ADDENDUM 01

Project Title: **Blinn Mechanical Project – Brenham – Melcher + BCPA Phase 2**
RSE Project #: **1540**

This **ADDENDUM** shall modify, amend, extend and become a part of the Contract Documents dated 1/13/25 prepared by Ramirez Simon Engineering, LLC (RSE) in accordance with the terms therein, as if written out in full therein and bound originally therewith.

PLUMBING
MELCHER FLOOR
PLAN

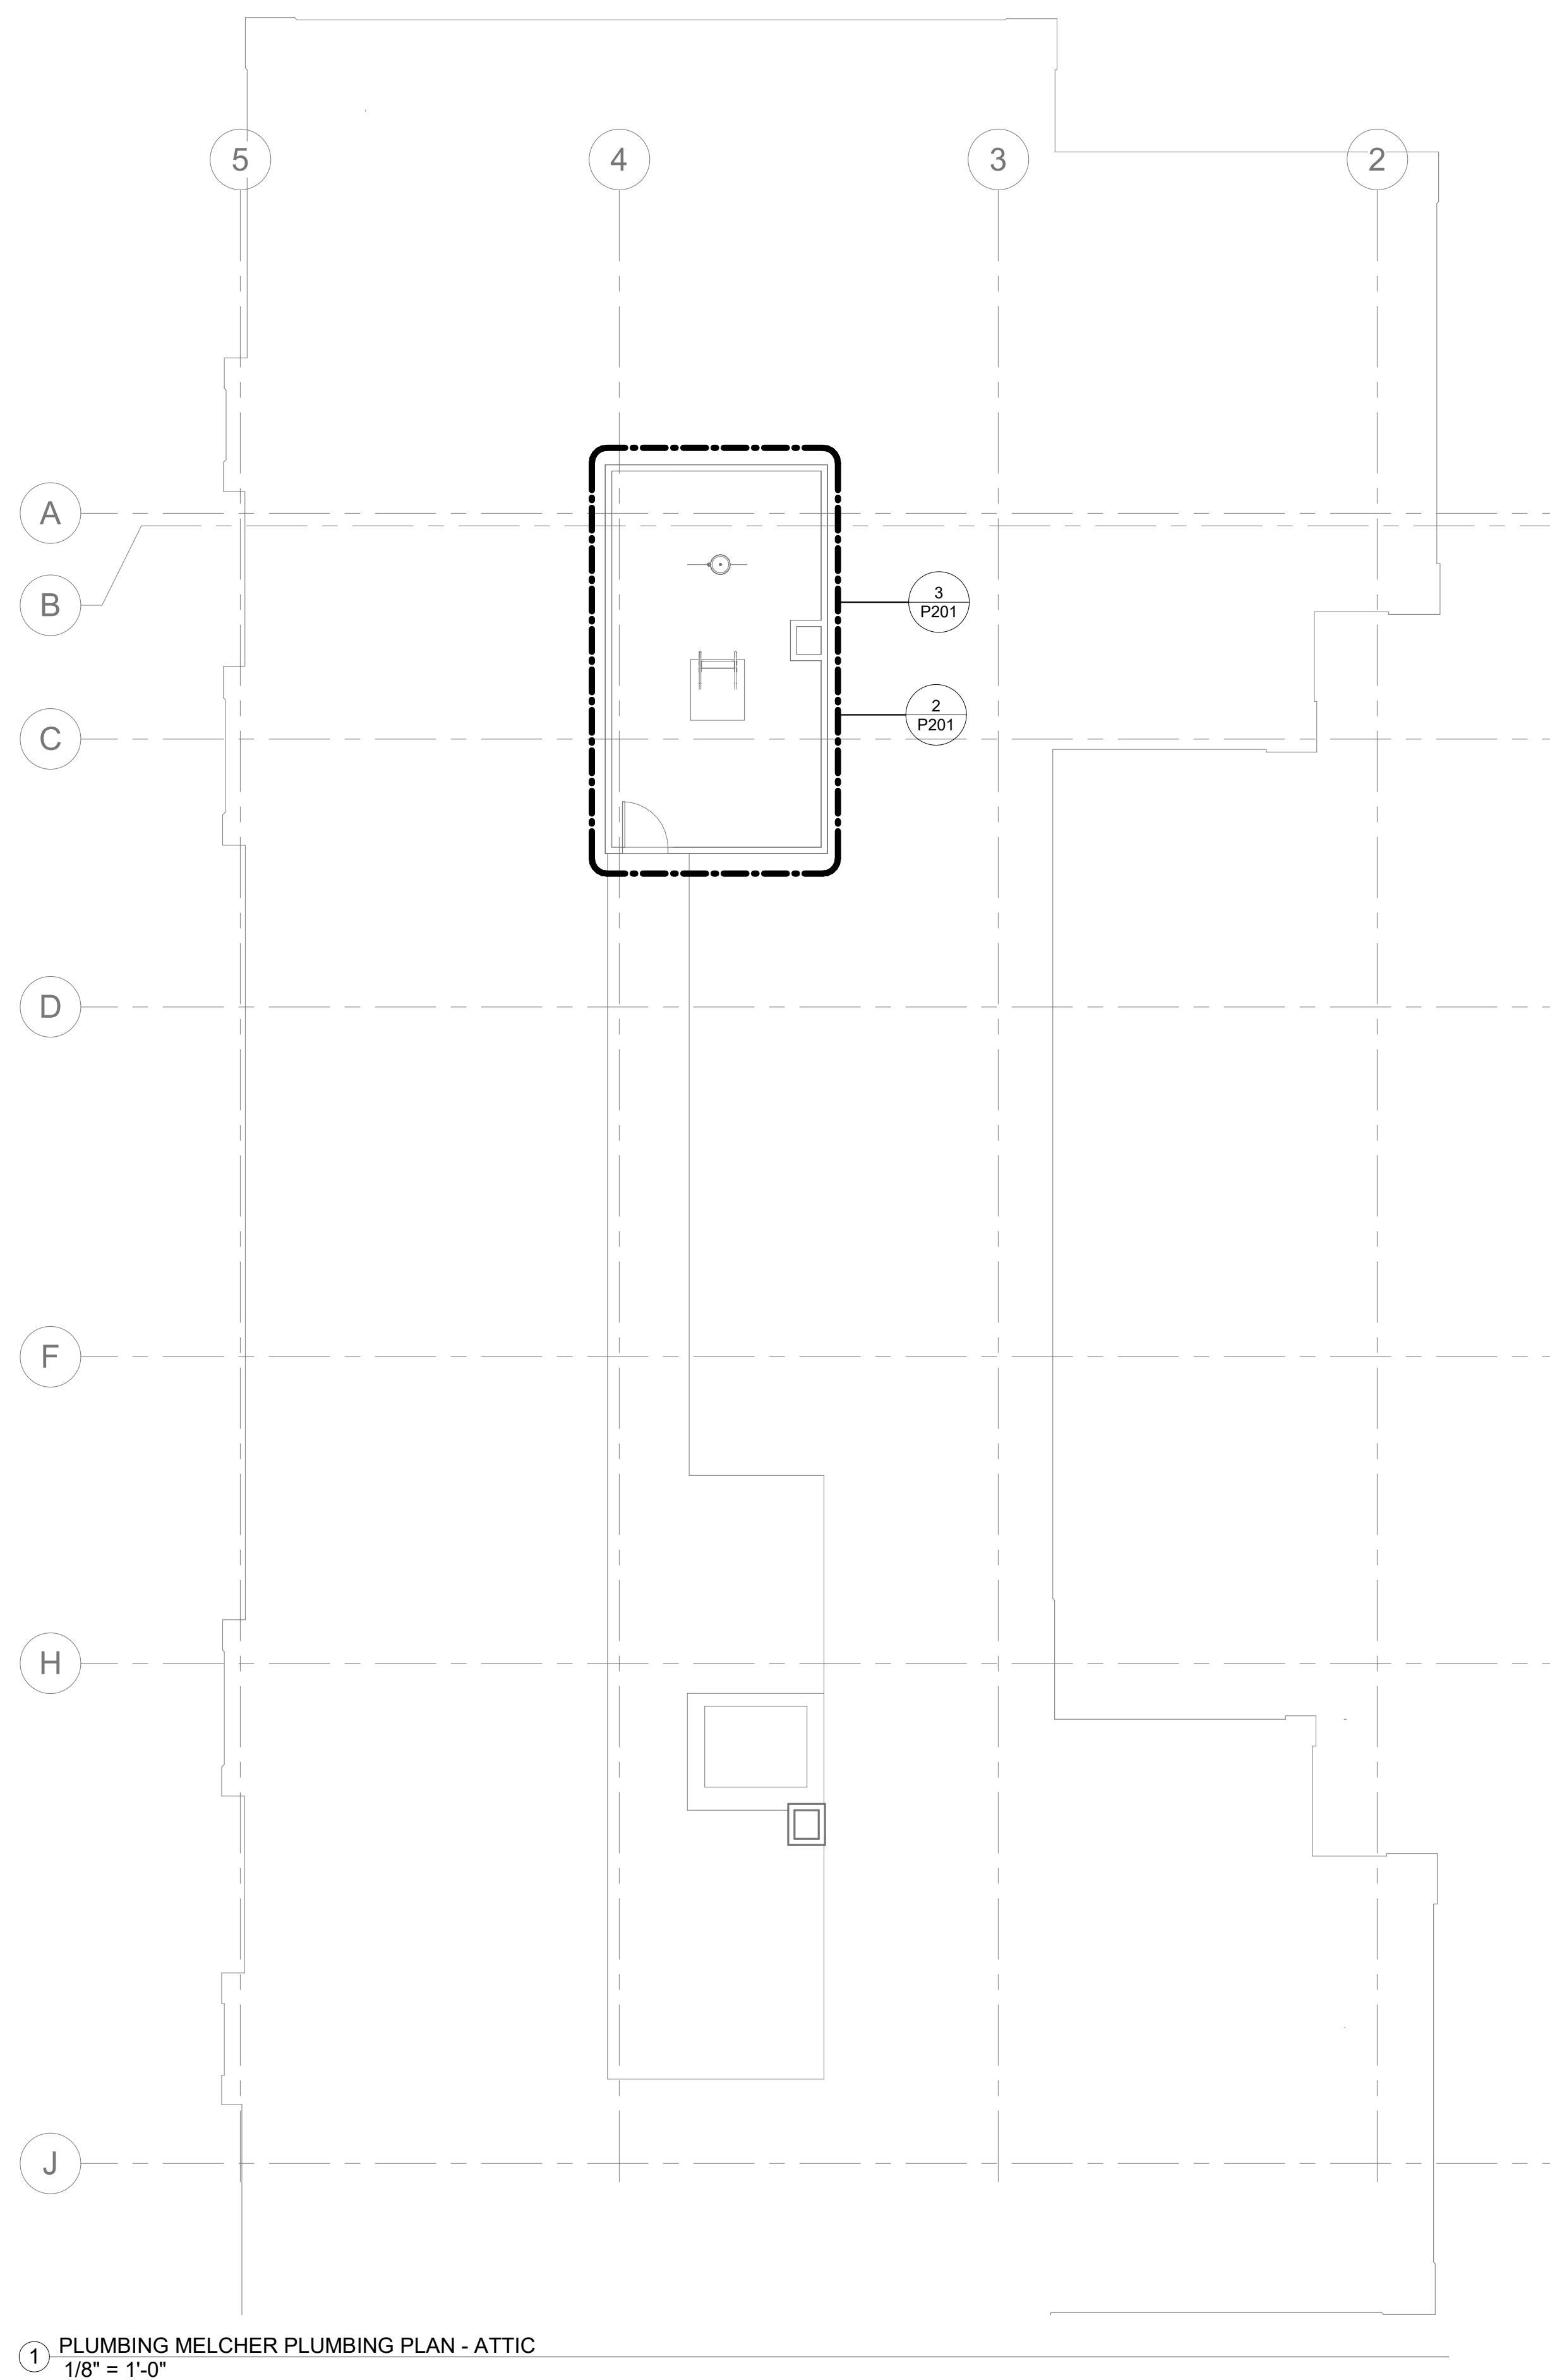
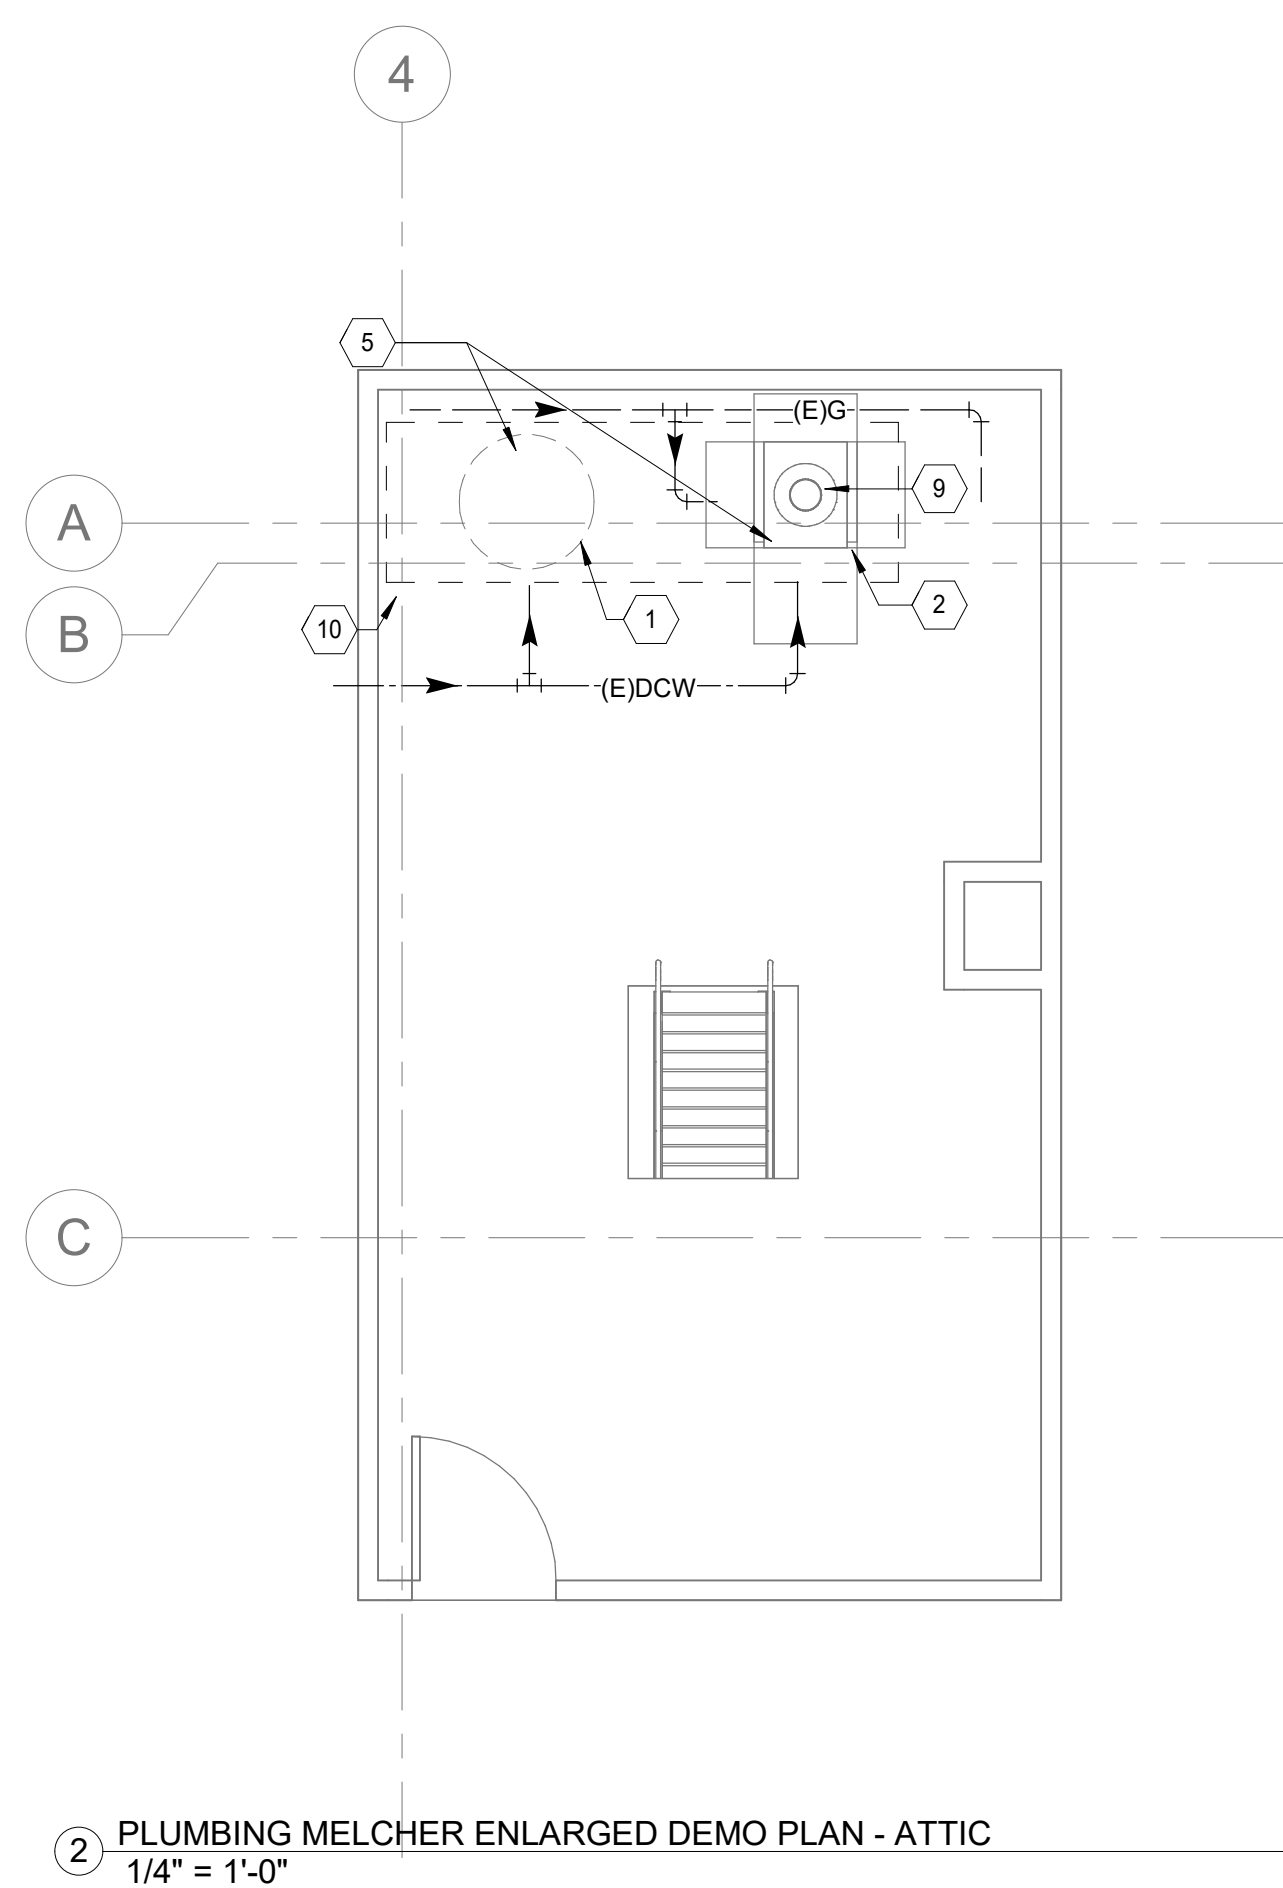
1. P201-PLUMBING MELCHER FLOOR PLANS
 - a. Updated Fixture Tag from B-3 to B-1 for new boiler.
 - b. Added notes to floor plan and to general note sections.
